City of Portland, Maine – Building or Use Permit Application 389 Congress Street, 04101, Tel: (207) 874-8703, FAX: 874-8716

BUILDING PERMIT REPORT

DATE: 3 March 2009 ADDRESS: Sunset Ave. Great Diamond CBL: 83B-H-004

REASON FOR PERMIT: Build a 9' x 31' screened in porch.

JOHN + KATHARINE CONDON
GREAT DIAMOND ISLAND

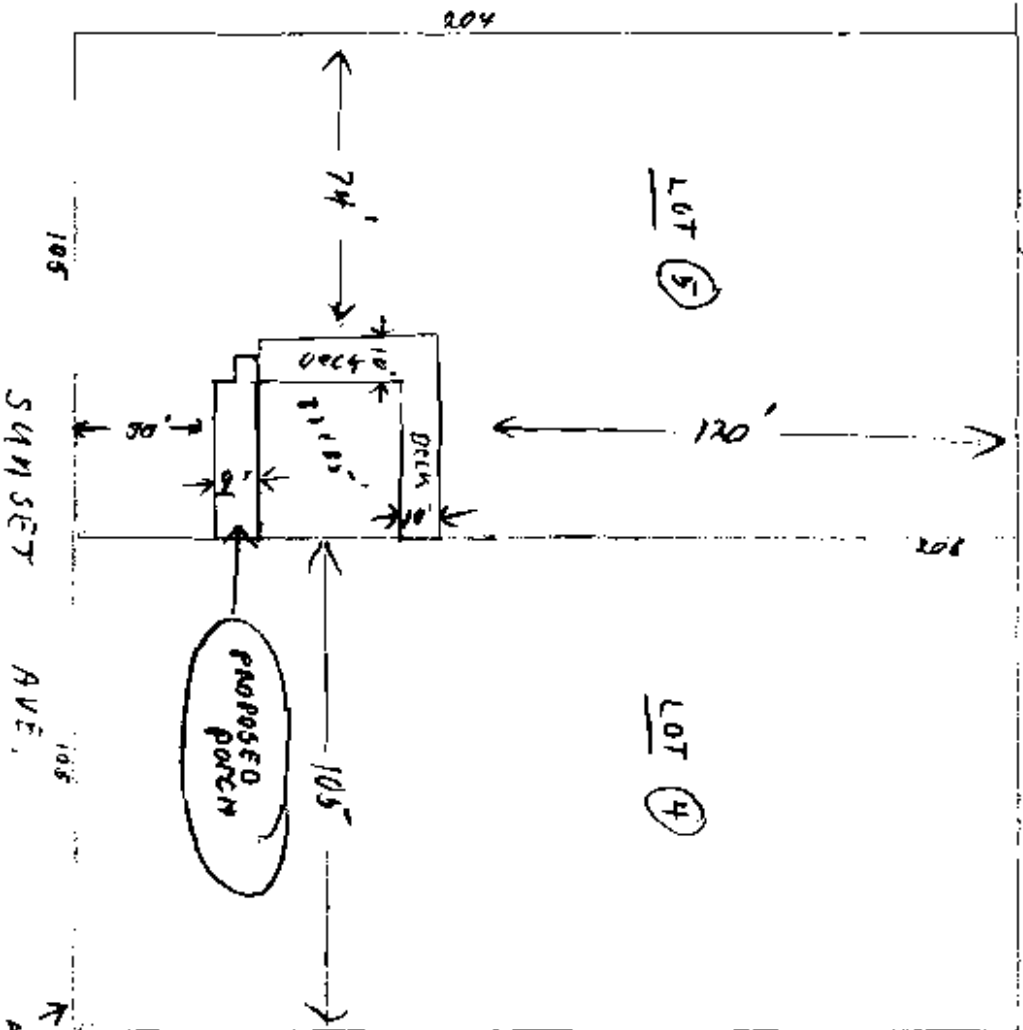
shall be setbacks
from the lot property lines
Not the setback line

PROPOSED
9x12
1" POICH
SCREENED
ADDITION

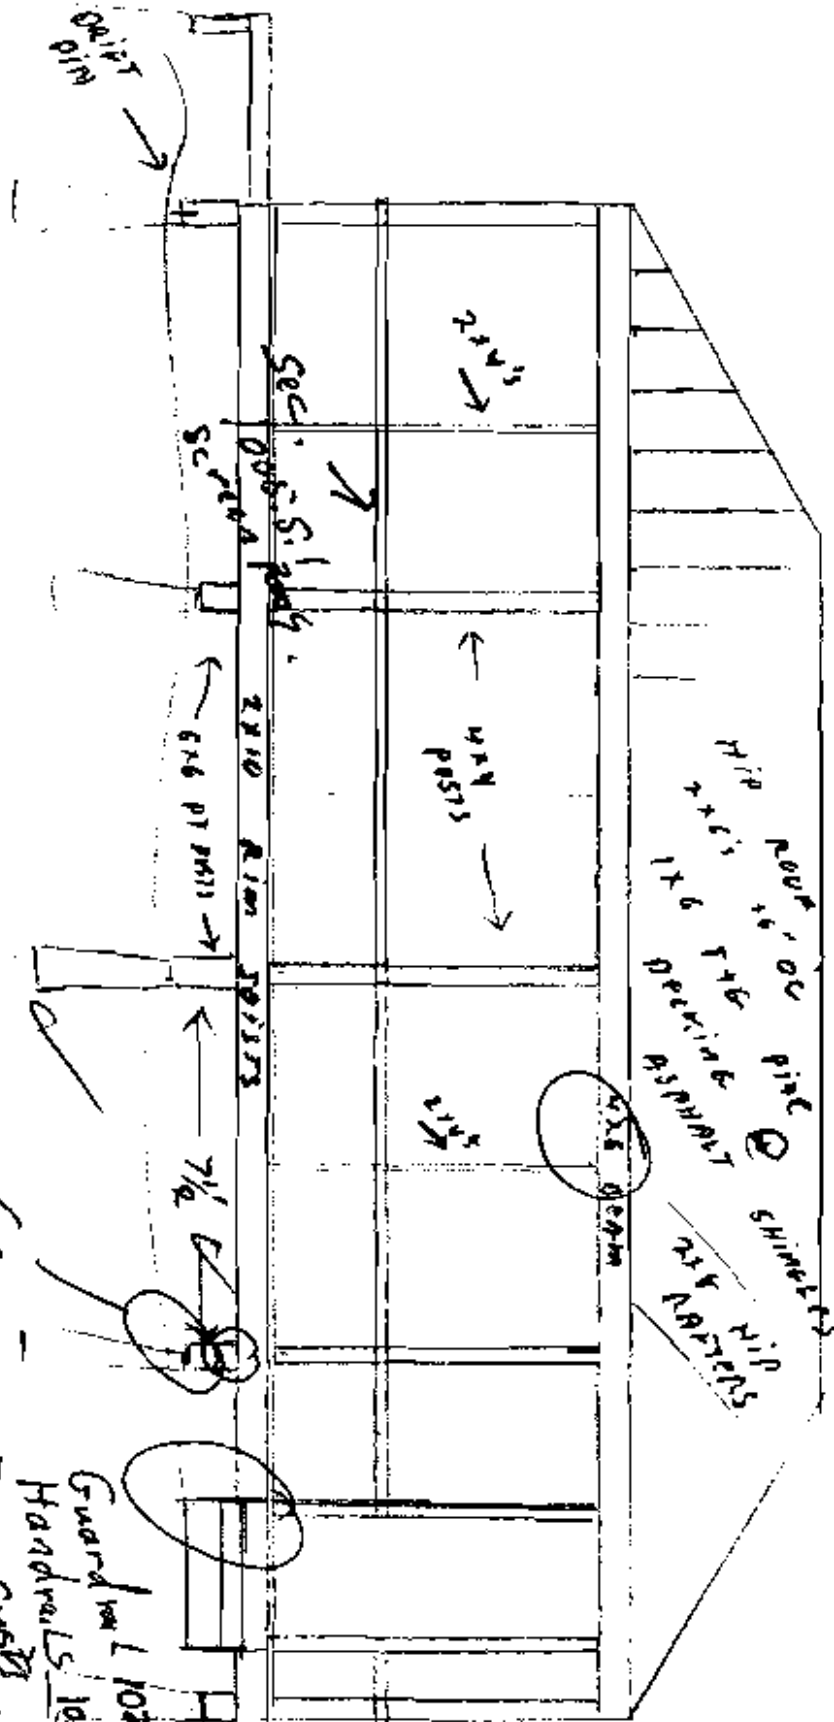
IR-2 Zone
Front: 25' req - 30' shown
Rear: 25' req - 120' shown
Side: 20' req - 74' 105' shown
NORTH

fasten

Guardrail 1021's
 Handrails 1022's
 STAINLESS TAPPAGE
 1014's
 columns

columns
 u' deep
 center
